DEVELOPMENT HEARING OFFICER (DHO)

PR-2018-001499

SD-2024-00139 – PRELIMINARY PLAT

REQUEST: Aces and Eights Development, LLC is requesting a Subdivision of Land-Major to create four (4) separate parcels. Upon successful completion of the subdivision, the parcels will be legally known as Tract A-1, Tract A-2, Tract A-3 and Tract A-4 of McMahon Commons.

The AGIS screenshot shows the area affected by the Zone Map Amendment.-

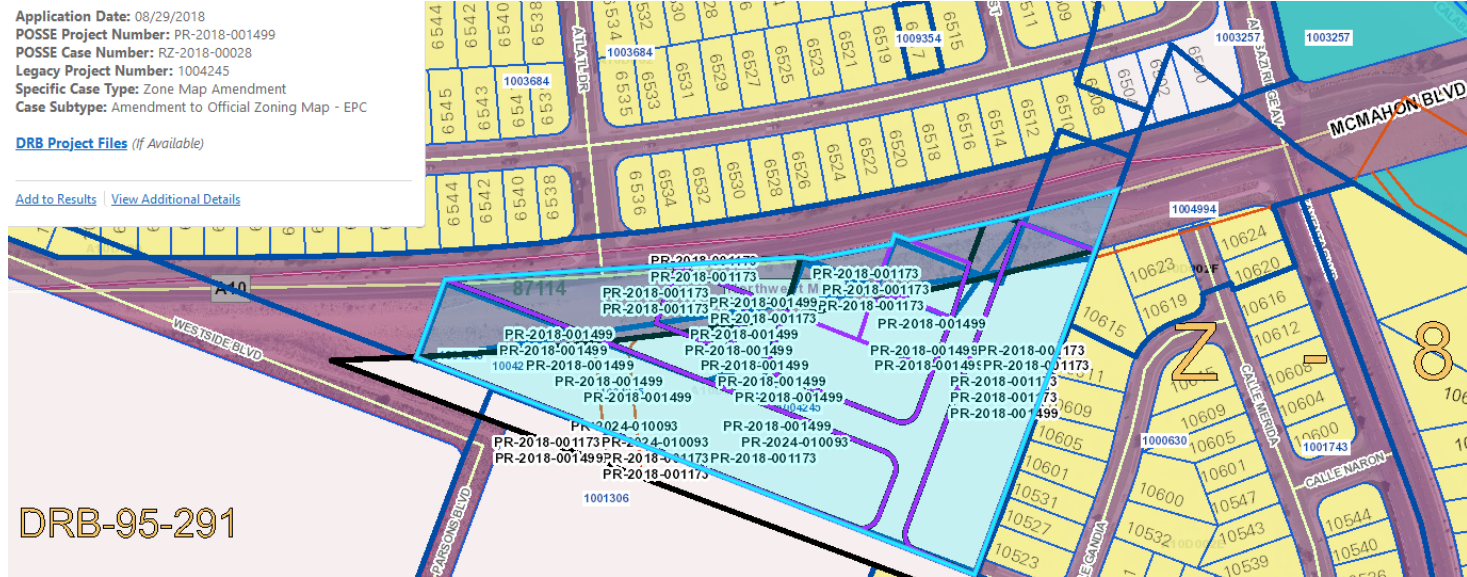
*After additional research, per the case history below, it was determined that there is an existing floating zone that will require a zone map amendment. However, it shouldn't delay an approval and should be able to be a condition of approval per the DHO.

The site went through a Zone Map Amendment in 2018. It included private property and City property. Later in 2018-2019, the lot below was opted into the Zone Conversion in the first year of the IDO. In 2020, the site went through several vacations and a Bulk Land Plat. However, that did not eliminate the floating zone that was created within the Zone Conversion.
